Response to David Allen and DCAS White Paper Dated April 2013:
"Issues Raised in February 21,2013 Work Group Meeting"
PA Cleared Version Released April 1, 2013

(April 5, 2013)

The GSI Stolen Radium-226 Plumb Bob Radiation Incident

Radium Industrial Radiography Source (ca. 1940s)

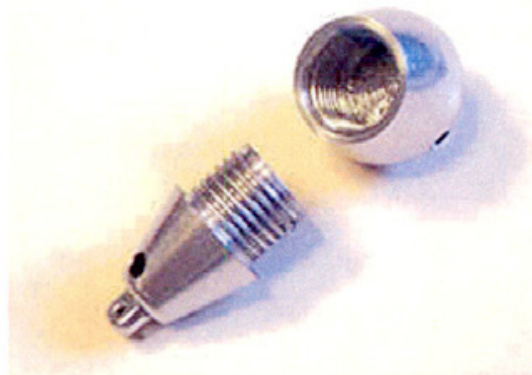
Attachment 1 (7 page source ref): Filename: GSI_RadiumPlumbBob1953.pdf
Research by GSI site expert [redacted] found stories from two Illinois newspapers, the Edwardsville Intelligencer, and the Granite City Press-Record, disclosed that a radium containing plumb bob source became missing at GSI that was recovered about a week later between approximately October 20 and 27, 1953. The petitioners contend that "plumb bob" is a term used almost exclusively to identify a radium-226 NDT source with that basic shape:

This is an example of an industrial radiography source of the type used in the 1930s and 1940s. Sometimes referred to as a plumbbob, it would have contained approximately 0.1 Ci of Ra-226. Although expensive, radium was used because no other radionuclides were then available of sufficient strength. After World War II, Ir-192 and Co-60 quickly became the radionuclides of choice and the use of radium was abandoned.

The same story appeared in a Washington State newspaper as well. The basic incident, minus the date information and the fact the plumb bob contained \$5,500 worth of radium according to United Press (Now UPI), was placed into the record at GSI worker outreach/affidavit meetings in 2006 and 2007. Drs. Ziemer (ABRWH, TBD-6000 work group chair) and Anigstein (SC&A) had previously stated on the record this story was "urban legend," "hearsay," or the incident occurred at another site (Attachment 1), none of which were true as this new evidence proves. SC&A has even shown this ORAU photo in one of its prior white papers.
